Lower Thames Crossing

9.196 Applicant's comments on Interested Parties' submissions at D7

Planning Inspectorate Scheme Ref: TR010032
Examination Document Ref: TR010032/EXAM/9.196

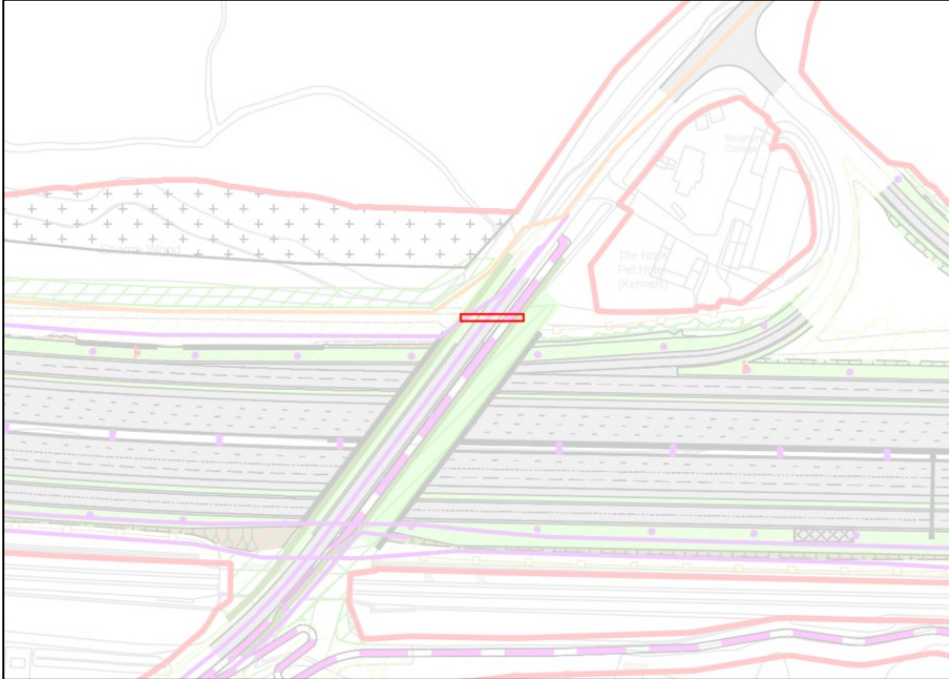
<p>The measures proposed to provide ancient woodland compensation planting have been developed without the inclusion of The Wilderness as a consideration. However, given the extent of this compensation planting and its design focus on a landscape-scale provision of habitat creation that develops strong coherent ecological networks, these proposals are considered to be appropriate and proportionate to the likely significant effects on ancient woodland that now include the area of designated ancient woodland within The Wilderness.</p> <p>Regarding the design of the Project, including utilities works, and how this has sought to avoid and minimise impacts to designated sites including the ancient woodland within The Wilderness, this was raised by the Examining Authority at their third round of questions under ExQ3_Q11.1.8. A full response to this has been provided by the Applicant in its response at Deadline 8 [Document Reference 9.192].</p>	Impact description	Importance	Level of impact	Effect	Significance	Construction					Permanent habitat loss at The Wilderness ASNW totalling 0.44ha	National	Major	Large adverse	Significant
Impact description	Importance	Level of impact	Effect	Significance													
Construction																	
Permanent habitat loss at The Wilderness ASNW totalling 0.44ha	National	Major	Large adverse	Significant													
Deadline 7 Submission –	Natural England	<p>Link to IP's submission:</p> <p>Comments regarding Mammal Culverts [REP7-215]</p>

Document title	Interested Party (IP)	Link to IP's submission / Applicant's response
<p>Comments on Applicant's submissions at Deadline 6</p>		<p>Applicant's response:</p> <p>The mammal culvert located at Brewers Road green bridge shall be provided at the north side of the bridge, between the existing and new bridge abutments as illustrated and shown in red in Plate 1. The mammal culvert located at Thong Lane green bridge south shall be provided south-west of the bridge, in the embankment under the southern connector road as illustrated and shown in red in Plate 2. These are indicative locations, to be finalised at detailed design, but have been based on the preliminary space proofing that has been undertaken to ensure that there is sufficient room for a 1.5m diameter culvert to be installed beneath the associated requirements for construction of the highways, drainage, utilities diversions and bridge structures.</p> <p>Plate 1 Indicative location for the Brewers Road green bridge mammal culvert</p>
